APPLICATION NO.	FILING DATE	FIRST NAMED INVENTOR	ATTORNEY DOCKET NO.	CONFIRMATION NO.
10/774,399	02/10/2004	Benjamin Arnette Lagrange	839-1433	9855
	7590 05/14/200 NDERHYE P.C.	EXAMINER		
901 NORTH GLEBE ROAD, 11TH FLOOR ARLINGTON, VA 22203			VERDIER, CHRISTOPHER M	
ARLINGTON, VA 22205			ART UNIT	PAPER NUMBER
			3745	
			MAIL DATE	DELIVERY MODE
			05/14/2007	PAPER

Application/Control Number: 10/774,399

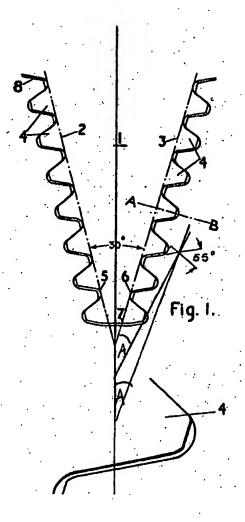
Claims 29-30, as far as they are definite and understood, are rejected under 35
U.S.C. 102(b) as being anticipated by United Kingdom Patent 677,142. Note the unnumbered bucket for insertion into an unnumbered wheelpost of an unnumbered turbine rotor in a third stage of a turbine, the bucket being formed from interleaved unnumbered fillets and tangs 4 which complement interleaved fillets and tangs formed in the wheelpost, with the two uppermost tangs on either side of a center line bisecting each of the buckets each respectively defining a point of a line that forms an angle of 25.78 degrees, with each of the points being determined by intersecting tangent lines along pressure faces of the respective uppermost tangs, and a point define by intersecting tangent lines along pressure faces of the bottommost tang does not lie on either line that forms the angle of 25.78 degrees. The bucket has three interleaved tangs and fillets. Note that these claims still do not specifically recite the particular geometry of the

intersection of the angle formed by tangent lines along uppermost tangs on either side of the center line bisecting each of the buckets. That is, a line drawn from the intersection of the angle formed by tangent lines to pressure faces of the two uppermost tangs (shown in figure 1 of United Kingdom Patent 677,142 at the intersection near the marked 55 degree angle as an example) on each side of a center line bisecting each of the buckets may be selectively drawn such that it intersects the center line (at a portion of the center line remote from the blade root) and forms the aforementioned 25.78 degree angle, with the lines defined by the uppermost tangs not coinciding with a point formed by the bottommost tang, such that this angle is the same as Applicant's angle E of 25.78 degrees in figure 10, since the location where the drawn line that forms the angle E intersects the center line is an arbitrary location. See the annotated figure below.

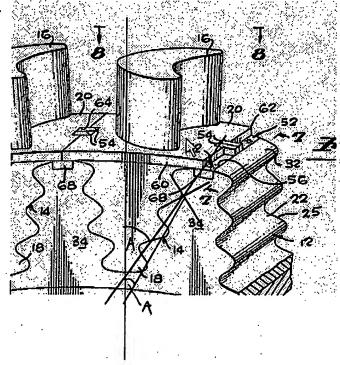
Claims 29-32 and 34-36, as far as they are definite and understood, are rejected under 35 U.S.C. 102(b) as being anticipated by Webb 3,202,398. Webb discloses a bucket 16 for insertion into a wheelpost 34 of a turbine rotor 10 in a third stage of a turbine, the bucket being formed from interleaved unnumbered fillets and tangs which complement interleaved fillets and tangs (near 22) formed in the wheelpost. The bucket has three interleaved tangs and fillets. The bucket has a bottom tang 18 formed from curved surfaces having more than one radius of curvature. The bucket further includes at least one straight surface (the leading and trailing edges). The bucket has an upper tang formed from curved surfaces having more than one radius of curvature. The two uppermost tangs on either side of a center line bisecting each of the buckets each respectively define a point of a line that forms an angle of 25.78 degrees, with each of the points being determined by intersecting tangent lines along pressure faces of the respective uppermost tangs, and a point defined by intersecting tangent lines along pressure faces of the bottommost tang does not lie on either line that forms the angle of 25.78 degrees. Note that these claims still do not specifically recite the particular geometry of the intersection of the angle formed by tangent lines along uppermost tangs on either side of the center line bisecting each of the buckets. That is, a line drawn from the intersection of the angle formed by tangent lines to pressure faces of the two uppermost tangs on each side of a center line bisecting each of the buckets may be selectively drawn such that it intersects the center line (at a portion of the center line remote from the blade root) and forms the aforementioned 25.78 degree angle, with the lines defined by the uppermost tangs not coinciding with a point formed by the bottommost tang, such that this angle is the same as Applicant's angle E of 25.78 degrees in figure 10, since the location

where the drawn line that forms the angle E intersects the center line is an arbitrary location. See the annotated figure below.

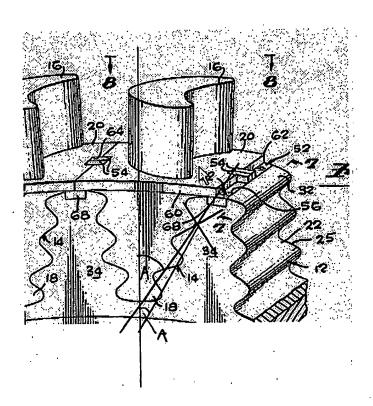
Claims 10-11, 13-17 and 21-25, as far as they are definite and understood, are rejected under 35 U.S.C. 103(a) as being unpatentable over Webb 3,202,398 in view of Applicant's Prior Art. Webb discloses a turbine substantially as claimed, comprising a wheel 10 having plural broach slots 22, each having an interleaved system of fillets and tangs, and plural buckets 16 each having a corresponding interleaved system of fillets and tangs so that the plural buckets can be filled, one to one, into the plural broach slots, with the interleaved system of fillets and tangs on the buckets and wheelposts 34 inherently acting to reduce stresses acting on the fitted buckets and wheelposts (due to the dovetail shape), the fillets and tangs of the interleaved system of fillets and tangs each being formed by a combination of curved and straight surfaces. The buckets and wheelposts have three interleaved tangs and fillets. Each of the buckets has a bottommost tang 18 formed from unnumbered curved surfaces having more than one radius of curvature (at the bottom of the tang and the top of the tang). Each bucket has straight surfaces (the leading and trailing edges). Each of the wheelposts has an unnumbered bottom fillet formed from curved surfaces having more than one radius of curvature (at the bottom and at the top). Each wheelpost includes unnumbered straight surfaces. The two uppermost tangs on either side of a center line bisecting each of the buckets each respectively define a point of a line that forms an angle of 25.78 degrees, with each of the points being determined by intersecting tangent lines along pressure faces of the respective uppermost tangs, and a point define by intersecting tangent lines along pressure faces of the bottommost tang does not lie on either line that forms the angle of 25.78 degrees. The two uppermost fillets on either side of a center line bisecting each of the buckets each respectively define a point of a line that forms an angle of 25.78 degrees, with each

of the points being determined by intersecting tangent lines along pressure faces of the respective uppermost fillets, and a point defined by intersecting tangent lines along pressure faces of the bottommost fillet does not lie on either line that forms the angle of 25.78 degrees. Note that these claims still do not specifically recite the particular geometry of the intersection of the angle formed by tangent lines along uppermost tangs and fillets on either side of the center line bisecting each of the buckets. That is, a line drawn from the intersection of the angle formed by tangent lines to pressure faces of the two uppermost tangs or fillets on each side of a center line bisecting each of the buckets may be selectively drawn such that it intersects the center line (at a portion of the center line remote from the blade root) and forms the aforementioned 25.78 degree angle, with the lines defined by the uppermost tangs or fillets not coinciding with a point formed by the bottommost tang or fillet, such that this angle is the same as Applicant's angle E of 25.78 degrees in figure 10, since the location where the drawn line that forms the angle E intersects the center line is an arbitrary location. See the annotated figure below.
